Index 18300 Concrete CCTV Pole

COMMENTS AND RESPONSES

INDEX 700-090

DYNAMIC MESSAGE SIGN WALK-IN

SHEET 1 of 5

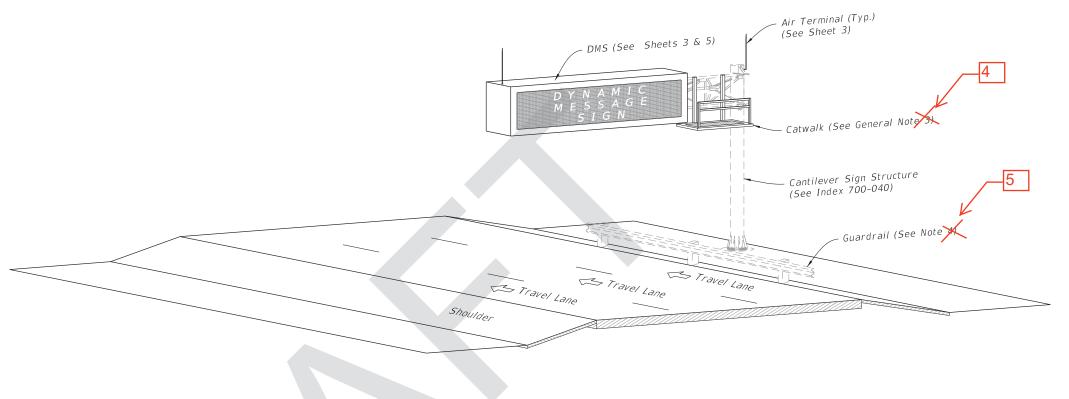
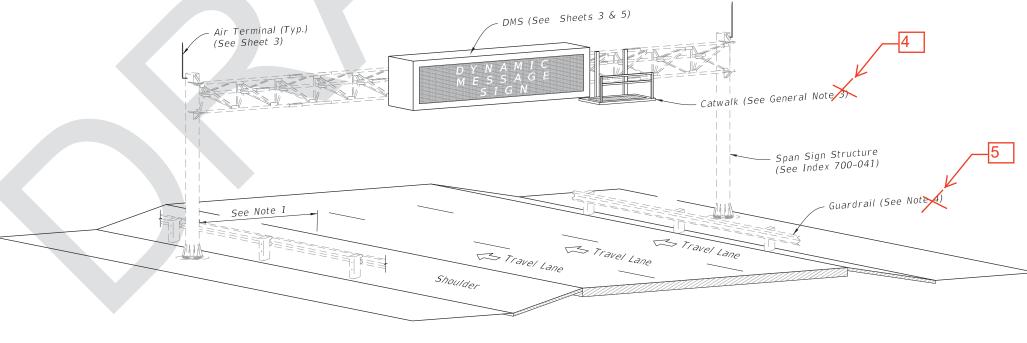
Sheet 1 of 5 – Check the numbering of the general notes. Number 6 is used twice.

Sheets 1 and 2 of 5 – Check the "See Note XX" references in the text tags based on the new note numbering. For example, the "Guardrail (See Note 4)" tag on both pages. Note 4 in the list is about extending the catwalk length.

Renumbered

Agreed, Changes made.
